HISTORIC AND DESIGN REVIEW COMMISSION

HDRC CASE NO: 2019-373
ADDRESS: 311 REFUGIO ST
LEGAL DESCRIPTION: NCB 714 BLK 11 LOT 11
ZONING: RM-4,H
CITY COUNCIL DIST.: 1
DISTRICT: Lavaca Historic District
APPLICANT: BRIAN VOGES/VOFGES DESIGN, LLC
OWNER: HOUSTON CARPENTER/HK DEVELOPMENT LLC
TYPE OF WORK: Construction of four, 2-story residential structures
APPLICATION RECEIVED: June 21, 2019
60-DAY REVIEW: August 20, 2019
CASE MANAGER: Adam Rajper
REQUEST:

The applicant is requesting conceptual approval to construct four, two-story single family residential structures on the vacant lot at 311 Refugio..

A1.0

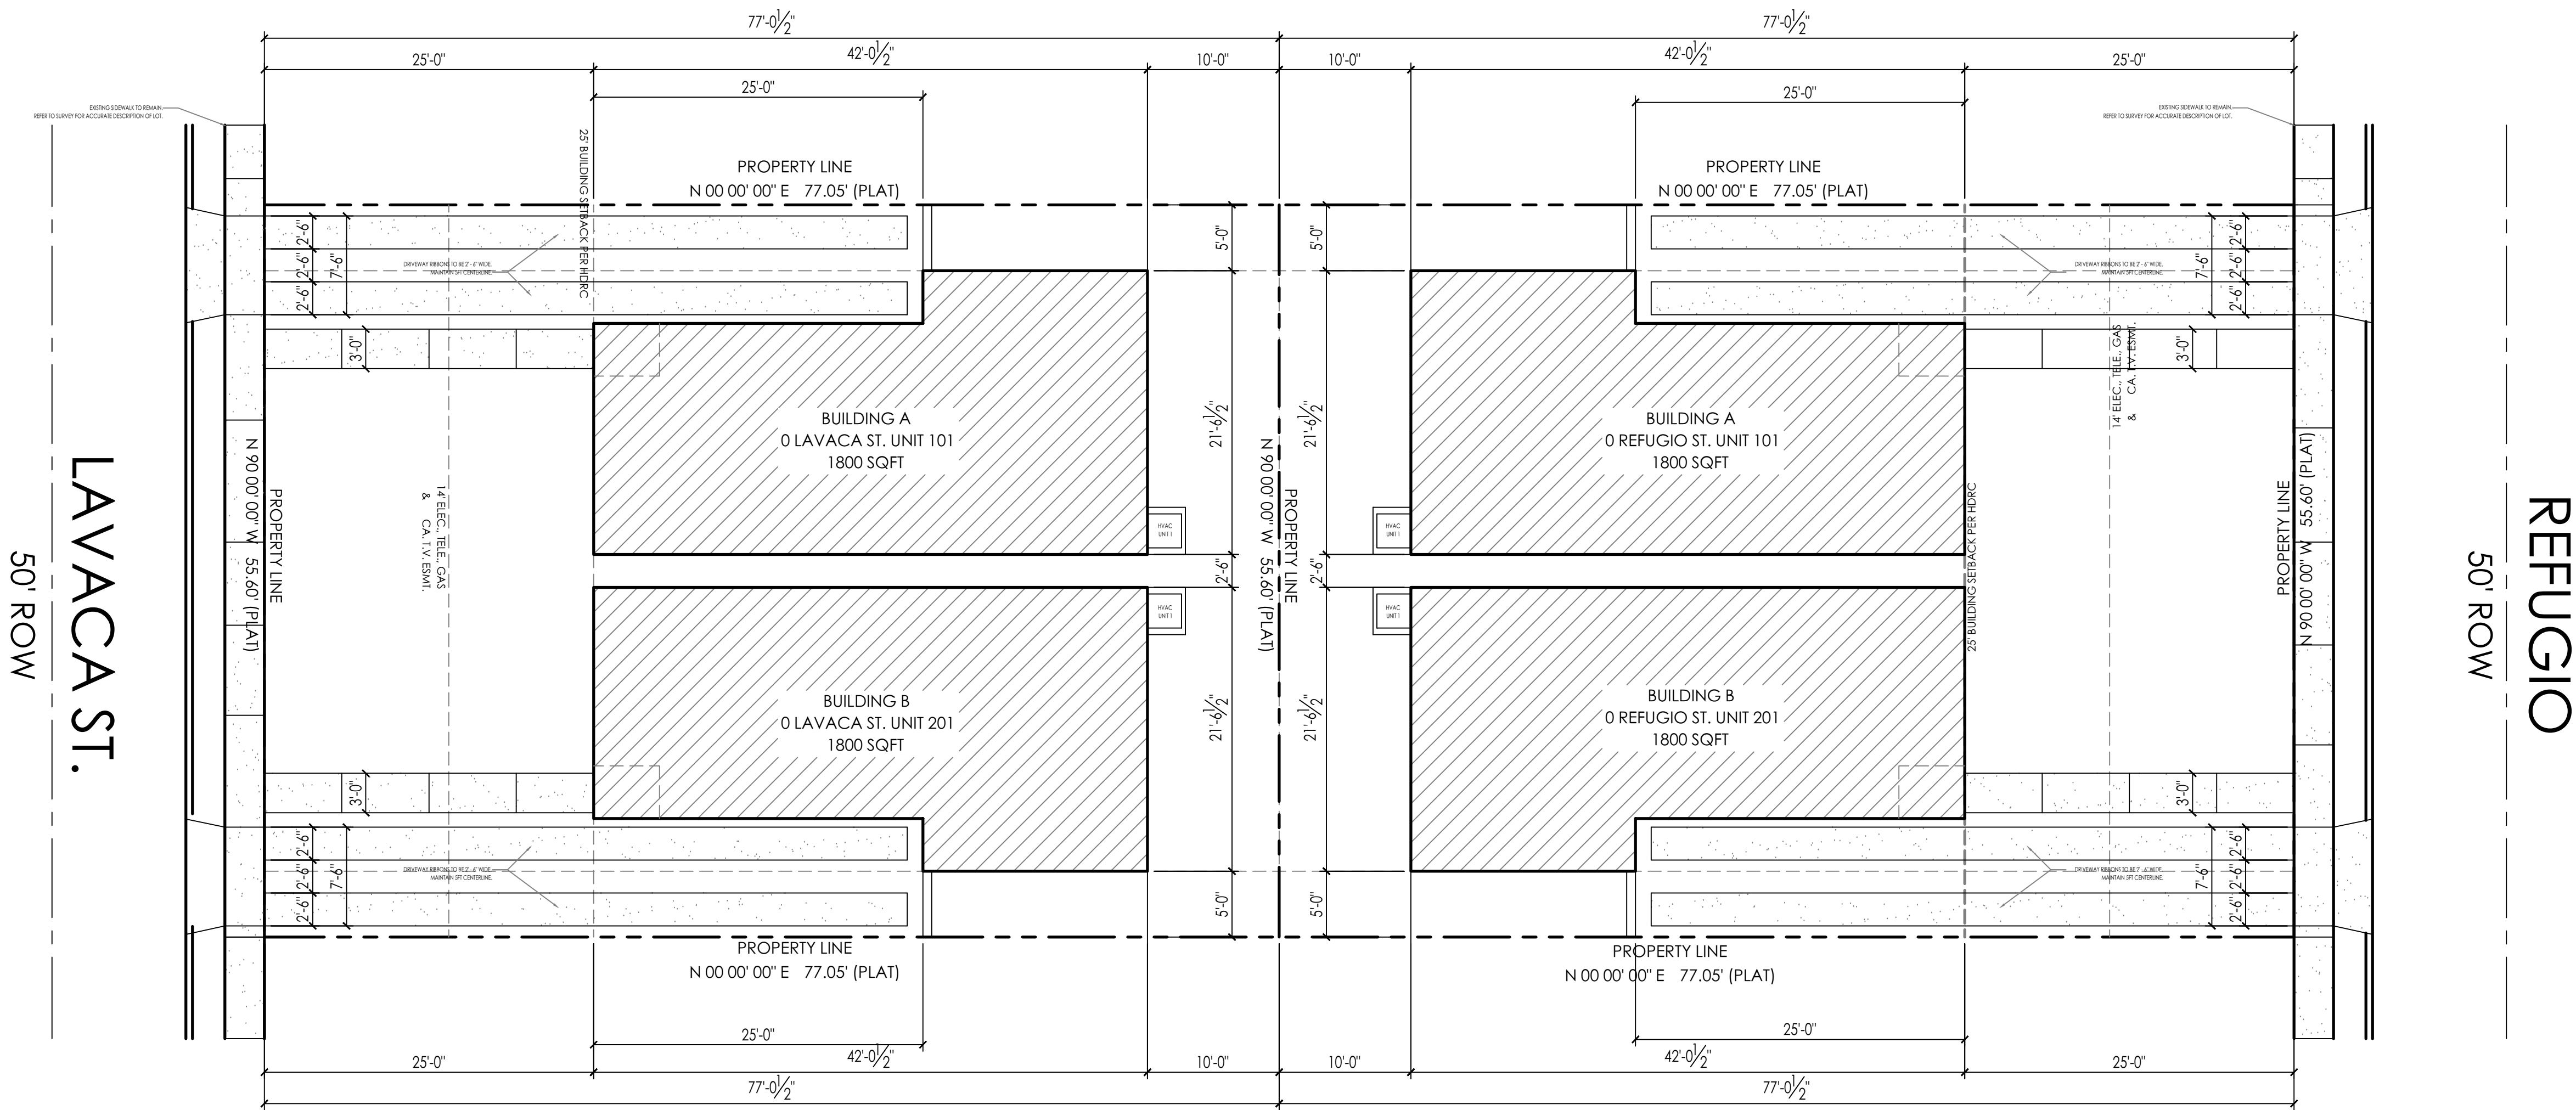
- i. **LOT COVERAGE** – Per the Guidelines for New Construction, the building footprint for new construction should be no more than fifty (50) percent of the size of the total lot area. Staff finds the proposal consistent with the Guidelines, per the submitted site plan.

- j. **BUILDING SEPARATION** – Per the submitted site plan, the proposed buildings will maintain a separation of 2'-6" along the north to south axis. According to the Historic Design Guidelines for New Construction, new buildings should generally follow historic development patterns. The existing context along Refugio and Lavaca includes primary structures that maintain at least a 10 to 15 foot separation. Additionally, according to the UDC, the fire-resistance rating of fire barriers and horizontal assemblies shall not be less than that specified for fire walls in Table 706.4 of the International Building Code. As proposed, fire walls would be required on the east and west sides of all four residences. Staff finds that the applicant should increase the building separation in order to achieve more consistency with the historic district, especially the properties situated along Refugio and Lavaca. As an alternative, the applicant should explore ways to attach the two groups of buildings and eliminate the separation between them.

- n. **DRIVEWAYS** – Guideline 5.B.i for Site Elements notes that new driveways should be similar to those found historically within the district in regards to their materials, width and design. Additionally, the Guidelines note that driveways should not exceed ten (10) feet in width. On the submitted site plan, the applicant has depicted ribbon

driveways that are situated along the northern and southern property line. As such, the driveways do not present front yard parking. Staff finds that the driveway location is consistent with the historic pattern on the block and throughout the district.

- v. That the applicant increases the building separation in order to achieve more consistency with the historic district as noted in finding j. The applicant should also explore alternatives to attach the two groups of buildings.

ALUMINUM CLAD CASEMENT- VERTICAL SECTION
SCALE: 6" = 1' 0"

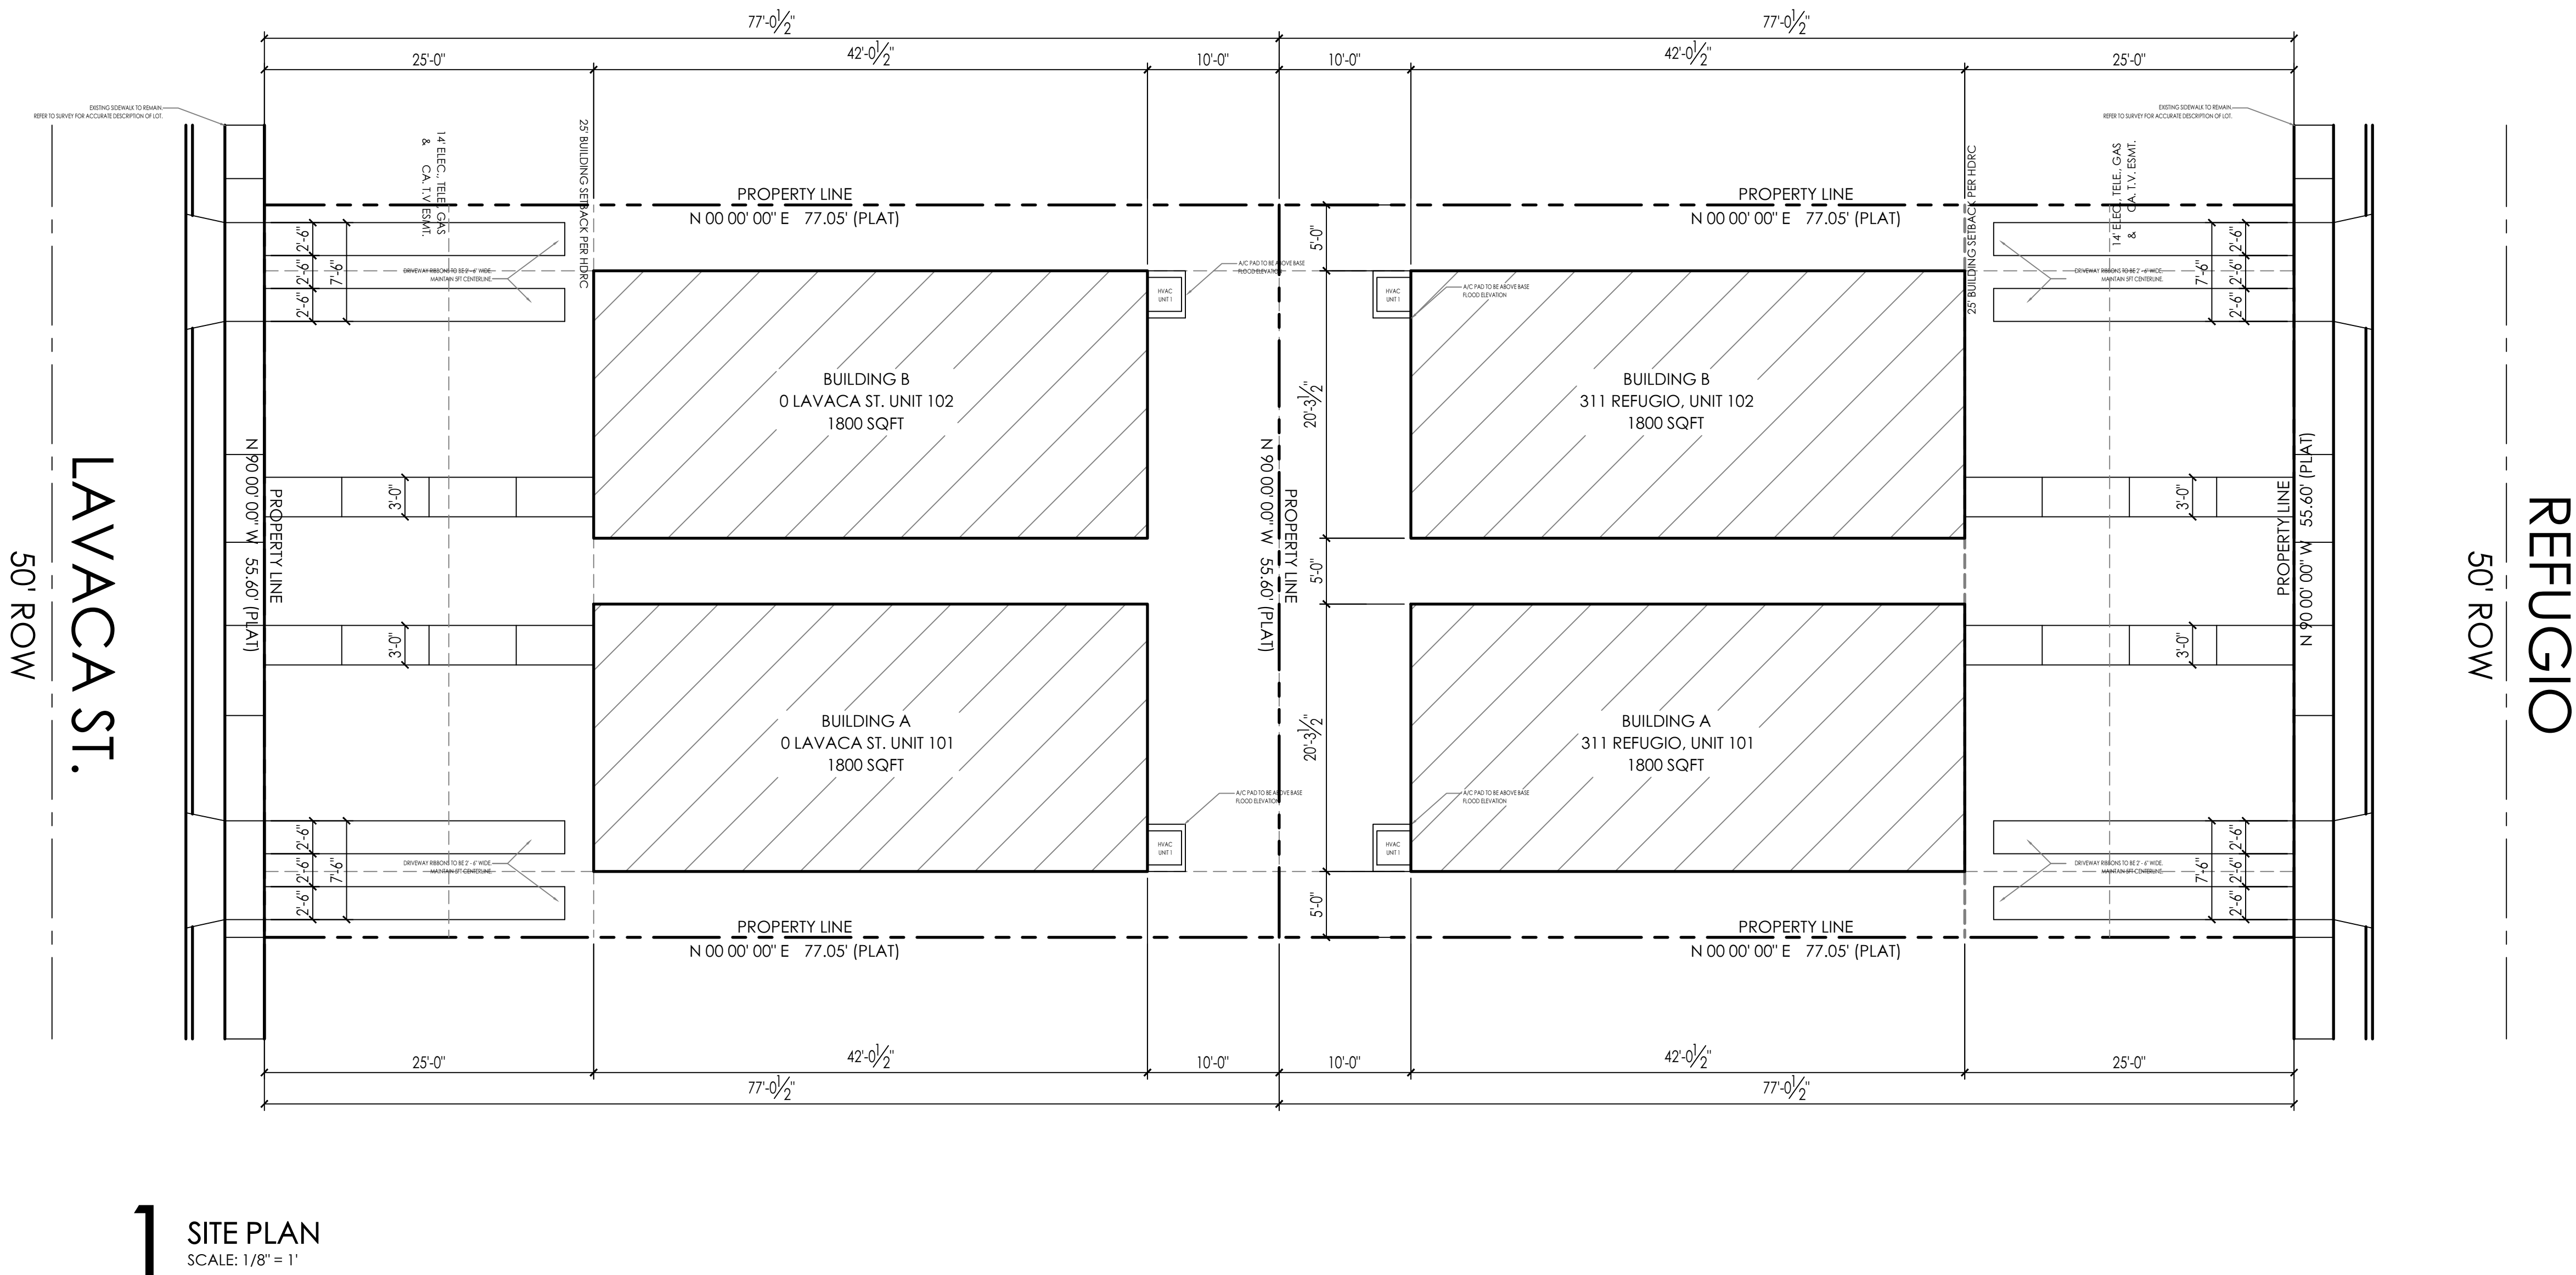
- l. **WINDOW MATERIALS** – The applicant has proposed aluminum clad casement windows. Staff finds that the windows should meet the following requirements: Meeting rails must be no taller than 1.25" and stiles no wider than 2.25". White manufacturer's color is not allowed, and color selection must be presented to staff. There should be a minimum of two inches in depth between the front face of the window trim and the front face of the top window sash. This must be accomplished by recessing the window sufficiently within the opening or with the installation of additional window trim to add thickness. Window trim must feature traditional dimensions and architecturally appropriate sill detail. Window track components must be painted to match the window trim or concealed by a wood window screen set within the opening.

- vi. That the applicant submit final window specifications for the proposed replacement windows to staff for review and approval. Meeting rails must be no taller than 1.25” and stiles no wider than 2.25”. White manufacturer’s color is not allowed, and color selection must be presented to staff. There should be a minimum of two inches in depth between the front face of the window trim and the front face of the top window sash. This must be accomplished by recessing the window sufficiently within the opening or with the installation of additional window trim to add thickness. Window trim must feature traditional dimensions and architecturally appropriate sill detail. Window track components must be painted to match the window trim or concealed by a wood window screen set within the opening.
